WEST HAVEN CITY
PLANNING COMMISSION AGENDA

Planning Commission
Staff Review Memo

PRELIMINARY SITE PLAN APPROVAL

SITE DEVELOPMENT PLANS
KUM & GO STORE #2523
1900 W & 2100 S

SHEET NUMBER:
C1.0
2 OF 11

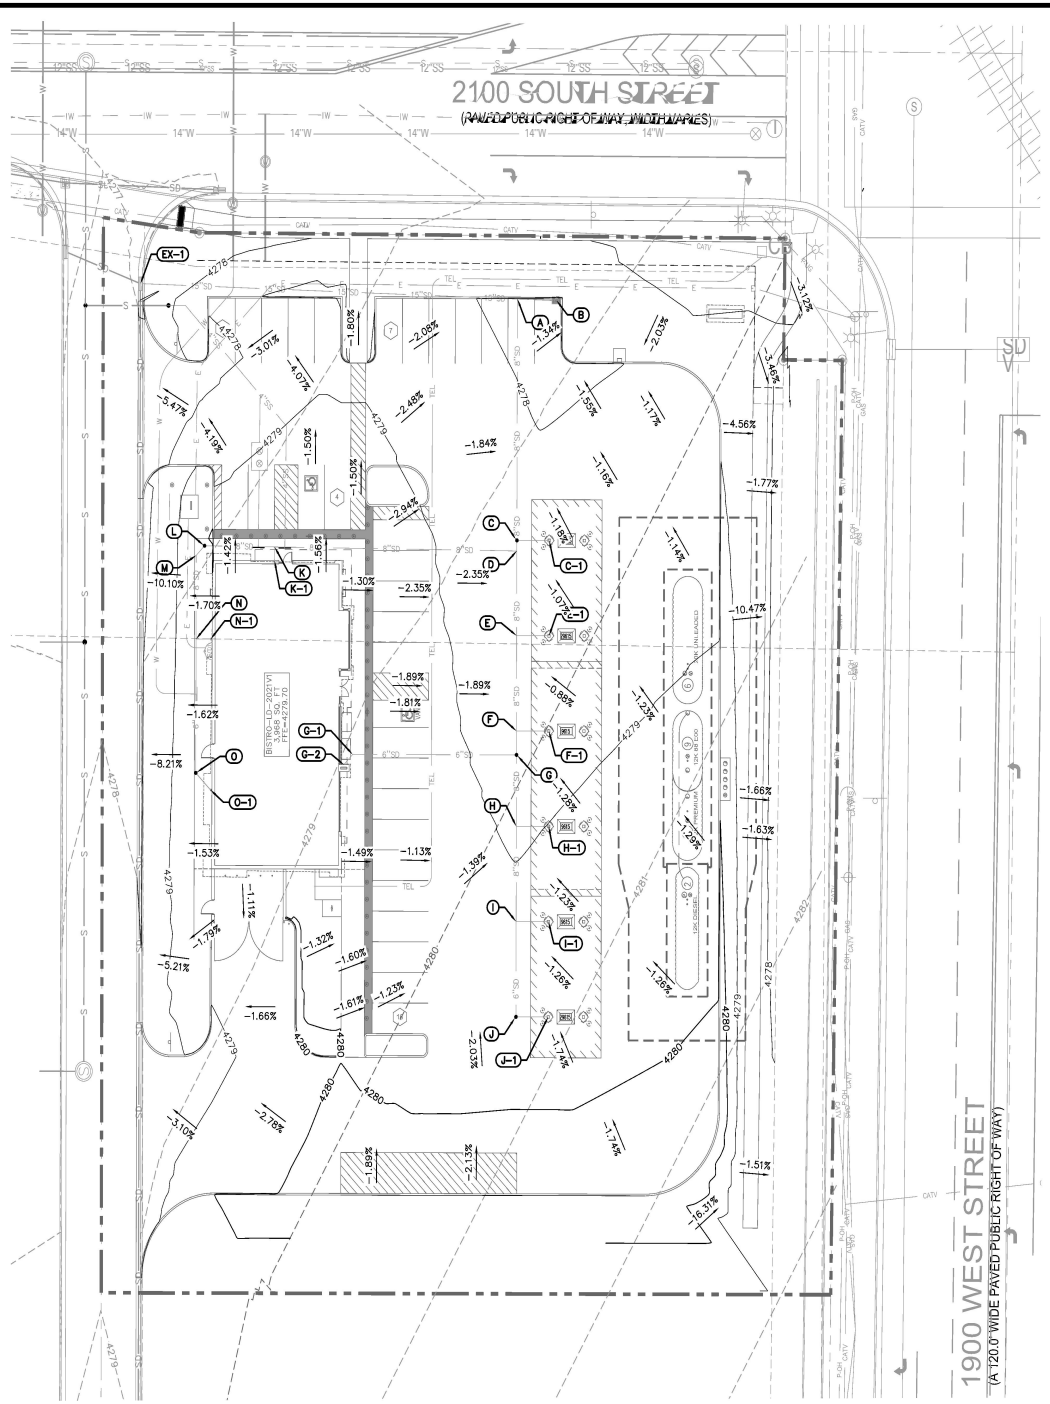
The closest use that is specified is a retail store, which requires 1 space per 250 square feet of floor space in the building. This standard would require 16 parking spaces on the site. ***The site plan proposes 18 total parking spaces. This satisfies the requirement and intent of the parking regulations.***

(1) Does the site plan comply with the West Haven City Engineering Design Standards and Specifications related to traffic ingress, egress and internal circulation? ***At the preliminary level, the site plan complies. There is an existing access to 2100 South, so no coordination with UDOT is required. As the final civil documents are prepared, the applicant will be required to make any minor modifications necessary to ensure the site is consistent with City standards.***

(B) Parking. Does the site plan comply with city ordinances regarding design, location and number of parking stalls required? ***See previous comments regarding parking.***

(a) Front yard. Landscaping shall be required along the entire frontage of the lot, except for the frontage required for ingress/egress. Said landscaping shall be a minimum of 15 feet deep, calculated from the property line. ***Because the building faces 1900 South, that is considered the front yard. As shown on the site plan (p 2/11) and the landscaping plan (p 5/11), there is 29.7' of landscaping along 1900 South, satisfying this requirement.***

Based on the above compliance with all relevant City codes, **it is Staff's position that the Commission should grant preliminary site plan approval, subject to the following conditions:**

- **Prior to final approval, the applicant shall provide the City with the following:**
  - **A will-serve letter from Bona Visa Water**
  - **Finalized elevations showing the distribution of architectural materials across the building to ensure compliance with the design criteria.**

SHEET NUMBER: A1.4

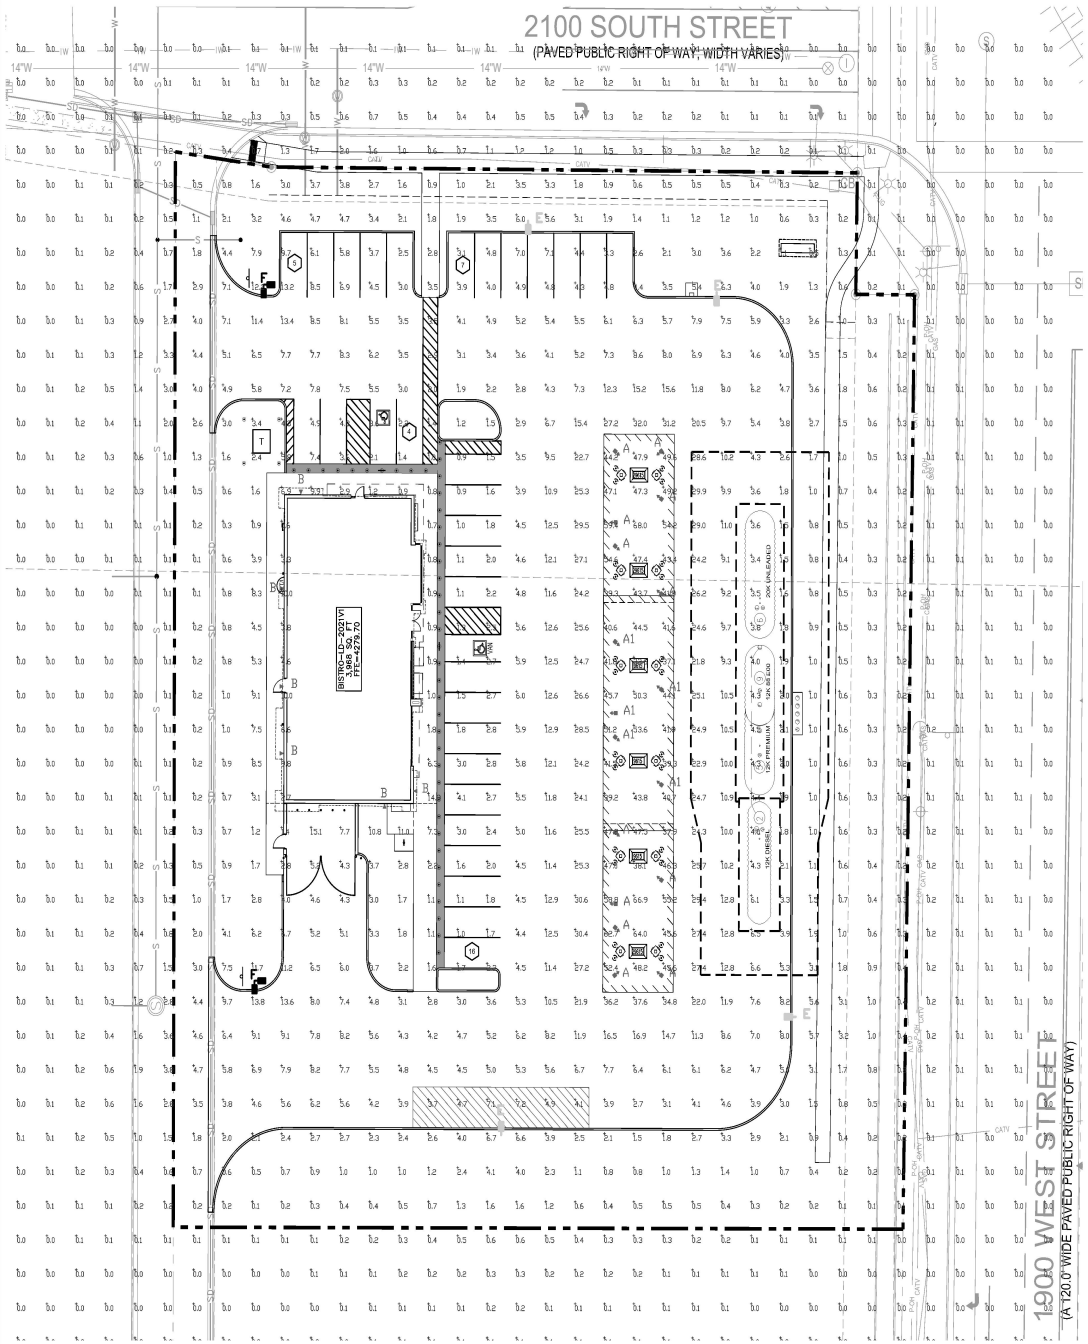
Because this is a standalone project rather than part of a commercial complex, it is a considered a "freestanding commercial" monument sign. The monument sign regulations for such are as follows (see sheet 10/11 of submittal docs for proposed sign design):

300-599 Linear Ft. Frontage	Requirement	Site Plan Proposal	Compliant
Max. area per sign face	65'	47'	Y
Max Height	8'	8'	Y
Max # of Signs	1	1	Y

Scale:	1"=20'	Drawn:	KJR
Date:	06/21/23	Job #:	23-0118
Sheet:	C3

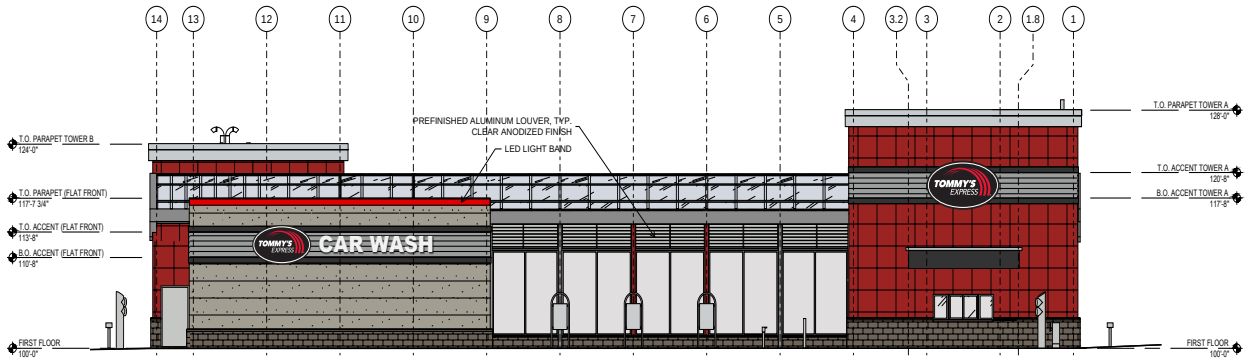
The site plan proposes to have three pay lanes with 27 car stacking in total. They also have 14 self-service stations and 8 parking stalls. They are compliant.

(1) Does the site plan comply with the West Haven City Engineering Design Standards and Specifications related to traffic ingress, egress and internal circulation? ***At the preliminary level, the site plan complies. There is access proposed on to 3600 South, but no coordination is required. There is also access onto Midland drive which the applicants have reached out to UDOT for a pre-application meeting. It is anticipated that there will be a shared driveway with the property to the South.***

(B) Parking. Does the site plan comply with city ordinances regarding design, location and number of parking stalls required? ***See previous comments regarding parking.***
The proposed parking stalls are 18x9 which falls just short of the required 180' square foot minimum. They will need to either be widened or slightly lengthened in order to comply.

- **Prior to final approval, the applicant shall provide the City with the following:**
    - **A will-serve letter from Taylor West Weber Water District**
    - **Update the dimensions of the parking stalls**

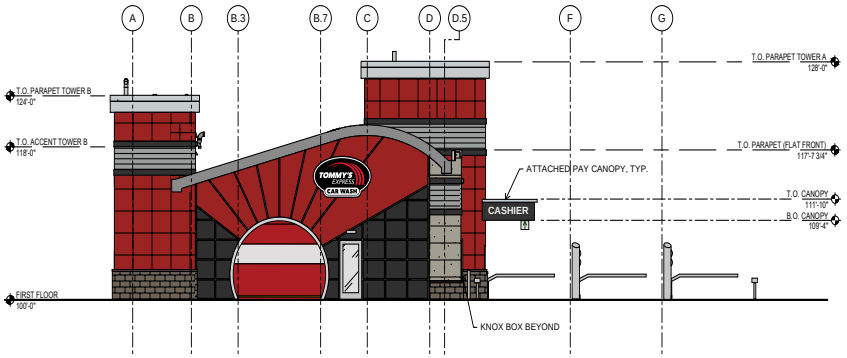
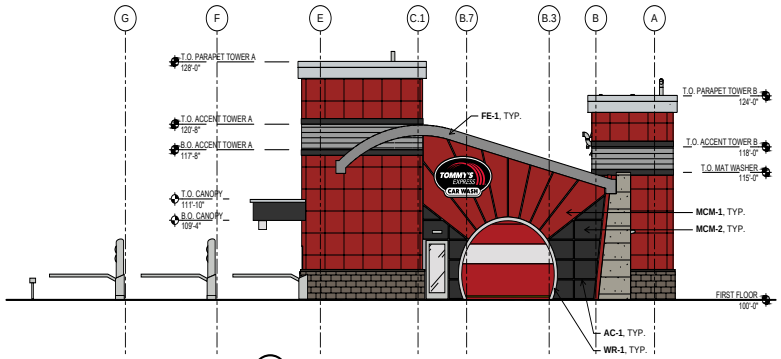
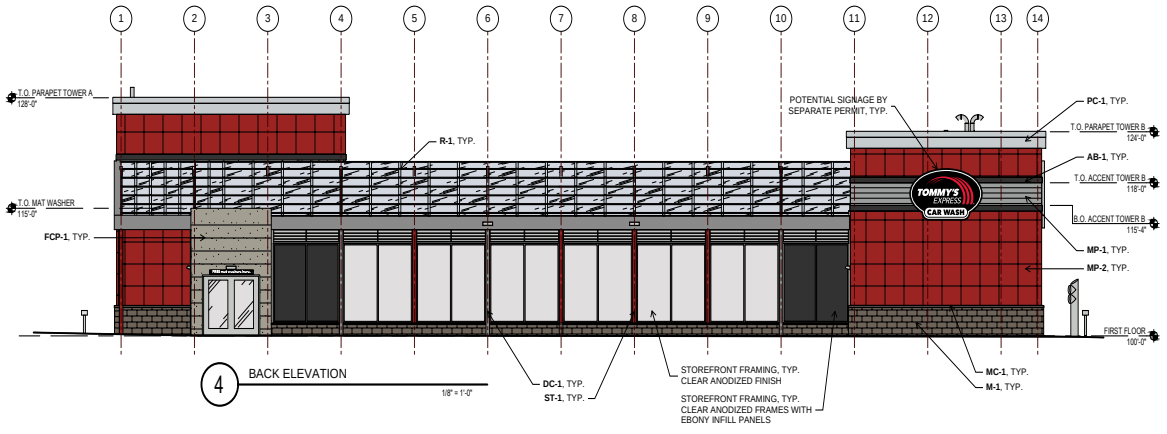
projections. ***The building is compliant with these requirements. There are breaks in the façade which area accomplished by varying building heights and change in materials.***
